**SUBJECT:** COMANCHE PEAK NUCLEAR POWER PLANT, UNITS 3 AND 4  
DOCKET NUMBERS 52-034 AND 52-035  
RESPONSE TO REQUEST FOR ADDITIONAL INFORMATION NO. 4224

**RESPONSE TO REQUEST FOR ADDITIONAL INFORMATION**

**RAI NO.: 4224 (CP RAI #134)**

**SRP SECTION: 13.03 - Emergency Planning**

Figure J-12. Evacuation Time Estimates  
Scenario 12, Region R03 (Entire EPZ)

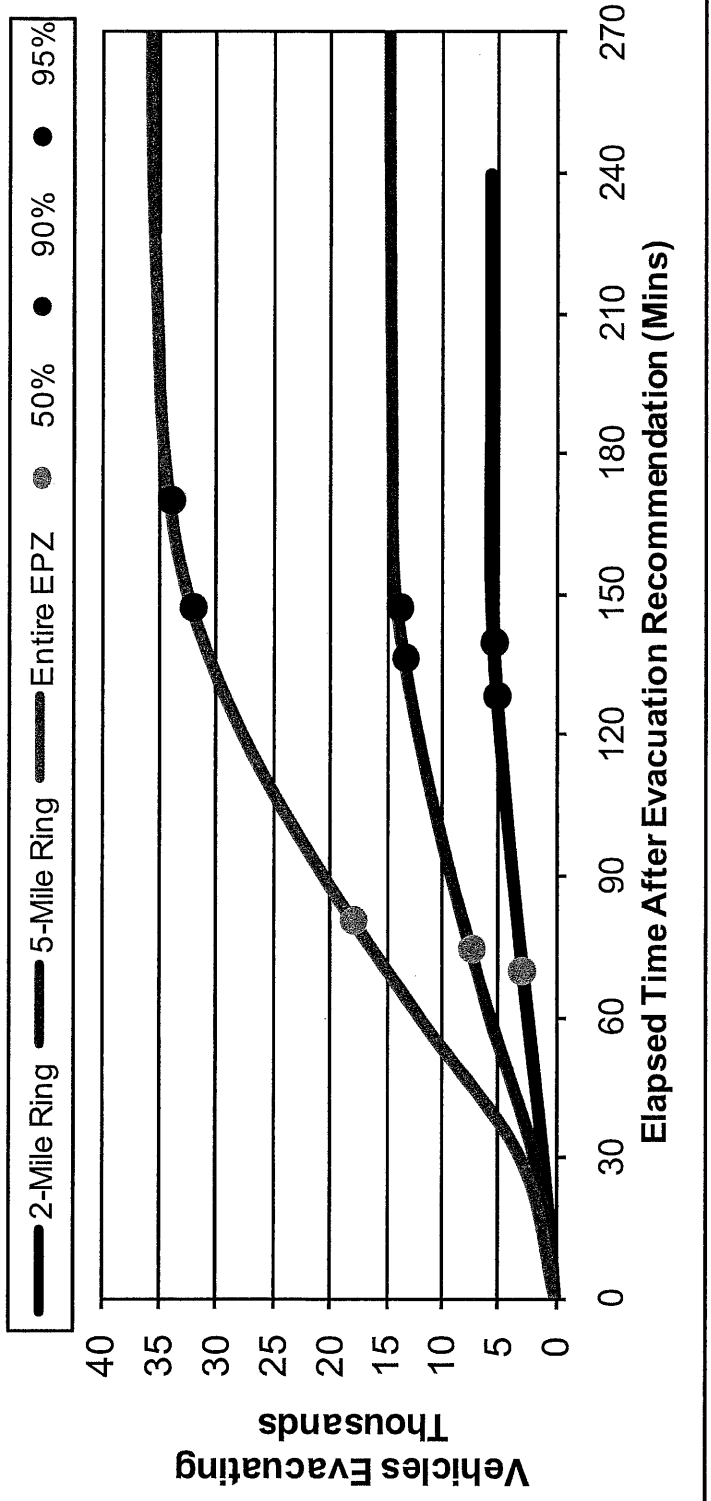
In response to RAI 13.03-19.B, the applicant explained that zone specific growth rates were multiplied by 15/7 in order to compute a growth factor to 2015 from the 2007 population estimate. However, the applicant did not explain in the response why a factor of 15/7 was selected to compute the 2015 population. Explain why a 15/7 factor was used to compute the 2015 population.

The growth factor of 15/7 discussed in the response to Question 13.03-019, part B, used to project permanent resident and shadow population to the peak construction year of 2015 is incorrect and should be 8/7. The base year used in this Evacuation Time Estimate (ETE) study is 2007. Population growth rates were computed for each Zone by comparing the Year 2007 populations to the Year 2000 populations, and arriving at a composite growth rate for the seven-year period.

To estimate an 8-year growth rate from 2007 to 2015, the composite growth rate for the 2000-2007 timeframe should have been multiplied by 8/7 and then applied to the 2007 population as a baseline. Correction of this calculation results in 2,695 fewer vehicles in the Construction Scenario (Scenario 12) evacuation simulation. Specifically, this resulted in a decrease in the number of permanent resident vehicles for Scenario 12 from 24,669 to 22,362 (total of "Residents with Commuters" and "Residents without Commuters" columns in Table 6-4) and a decrease in the number of shadow vehicles from 4,324 to 3,936.

The growth factor was corrected to 8/7 in the data input stream and all simulation cases were re-run as a result. The ETE for Scenario 12 in Tables 7-1C and 7-1D in the Executive Summary, in Tables 7-1A through 7-1D in Section 7 and in Tables J-1A through J-1D, and Figure J-12 in Appendix J have been revised based on the new simulation runs. Table 6-4 in Section 6 has also been revised to reflect the correct number of permanent and shadow vehicles.

Figure J-13. Evacuation Time Estimates  
Scenario 13, Region R03 (Entire EPZ)

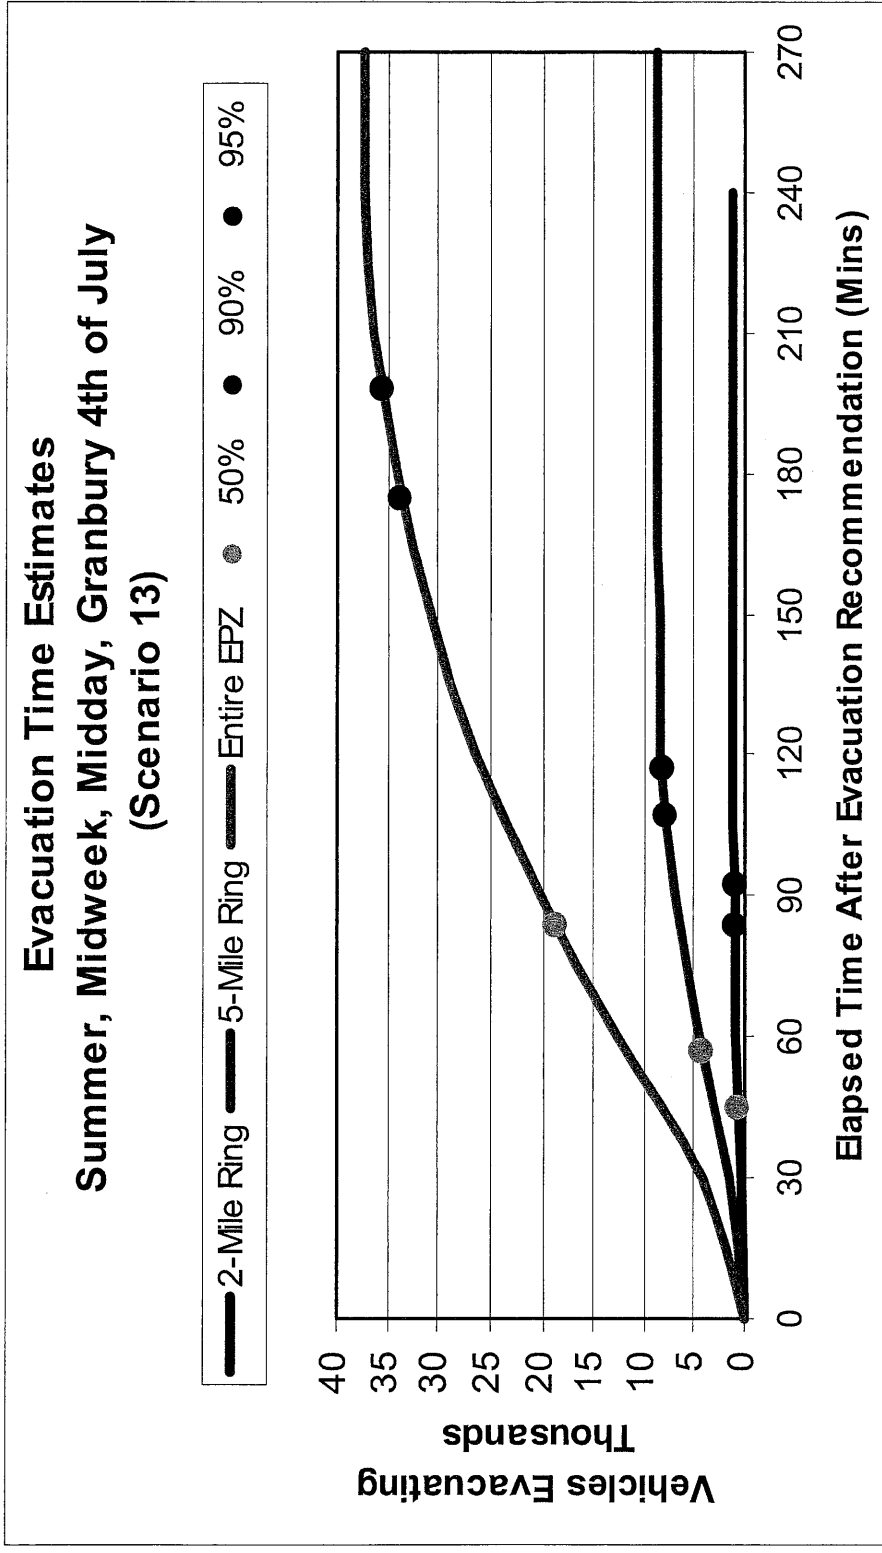
In response to RAI 13.03-20.C, the applicant agreed that the Fourth of July Celebration will be added as a special events scenario. The applicant's response also provided the specific textual changes that will be made to the evacuation time estimate (ETE) text and tables in an updated ETE Report. However, the applicant did not provide updated Tables 7-1A through 7-1D, "Time to Clear the Indicated Area of [X] Percent of the Affected Population." Provide updated Tables 7-1A through 7-1D showing the addition of Scenario 13. Update the ETE accordingly.

As discussed in Luminant's response to Question 13.03-20, the Fourth of July Celebration in Granbury is no longer treated as a sensitivity study. The Fourth of July Celebration has been added to the ETE Report as a special event and is identified as Scenario 13. The "Impact on R-COLA" section of that response stated that several changes to the ETE report to incorporate Scenario 13 were necessary, but had yet to be completed. The analysis of Scenario 13 has been completed and the following additional changes have been made in Revision 3 of the ETE Report:

- Tables 7-1A through 7-1D include Scenario 13 (Tables 7-1C and 7-1D in the Executive Summary also include Scenario 13)
- Tables J-1A through J-1D include Scenario 13
- Appendix J includes a plot of evacuating vehicles vs. elapsed time after the advisory to evacuate for Scenario 13 as Figure J-13
